02-2017 LATEST REVISION DATE	<i>Norman E. Mc Donald</i> APPROVED BY BRIDGE ENGINEER		
		STANDARD DESIGN - 40' ROADWAY, 3 SPAN BRIDGES ROLLED STEEL BEAM BRIDGES OCTOBER, 2014	
		FRAMING PLAN 160'-0 BRIDGE	RS40-041-14

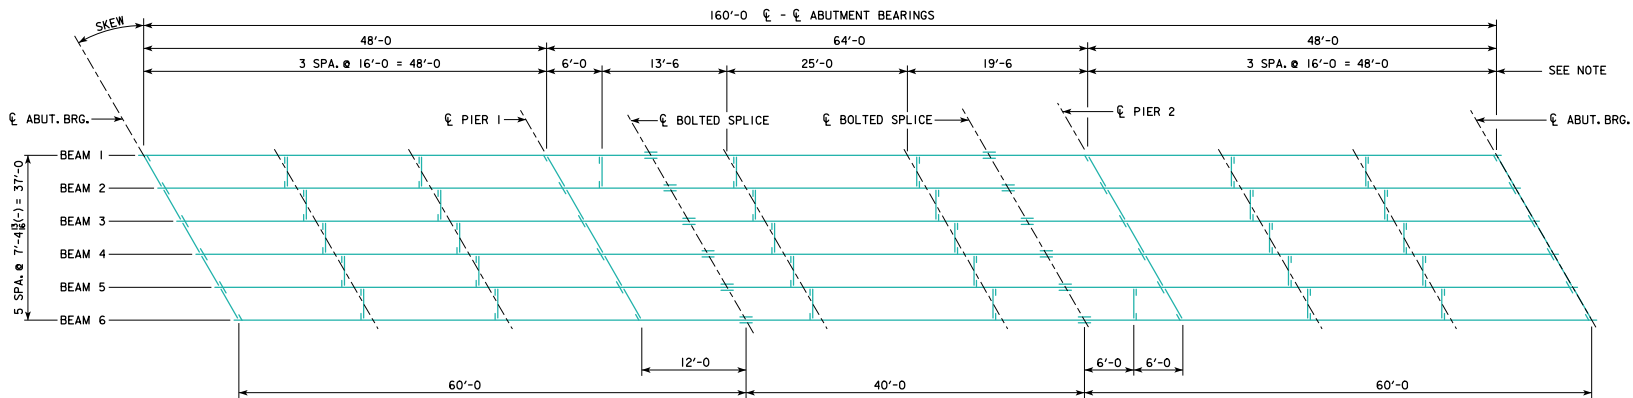
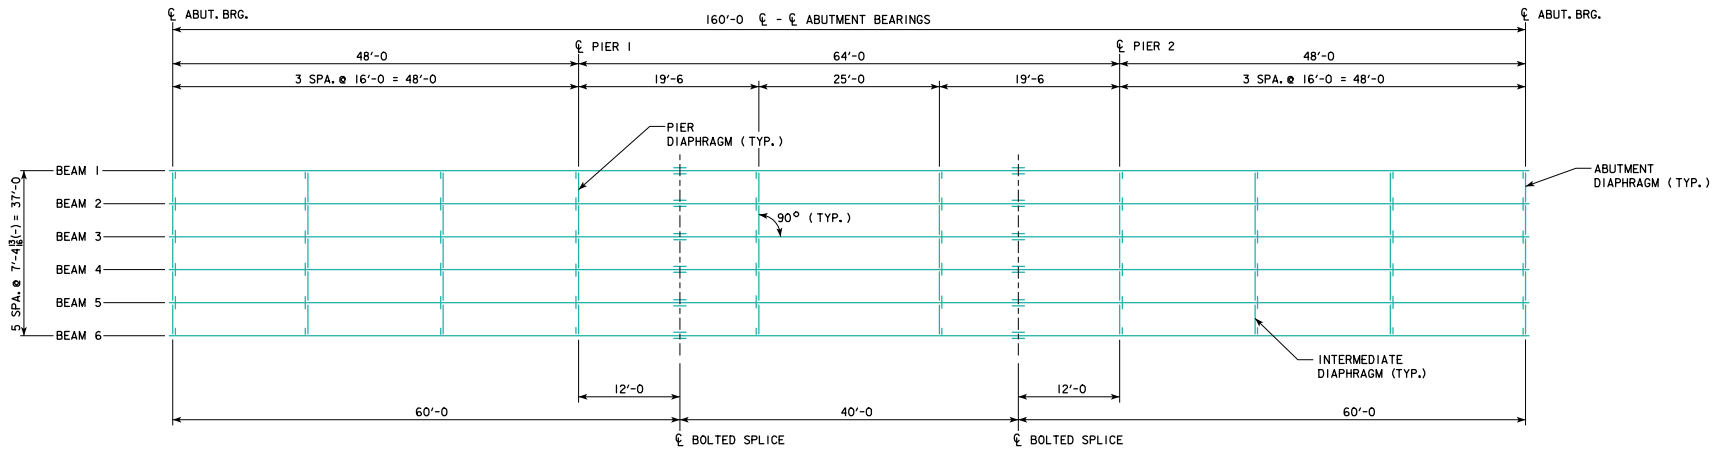
REV/ISED 02-2017 - ADDED DIAPHRAGMS TO SKEWED FRAMING PLAN IN OUTER BAYS, BETWEEN BEAMS 1 & 2 AND 5 & 6 OF 64'-0" CENTER SPAN, 6'-0" FROM PIER CENTERLINES.
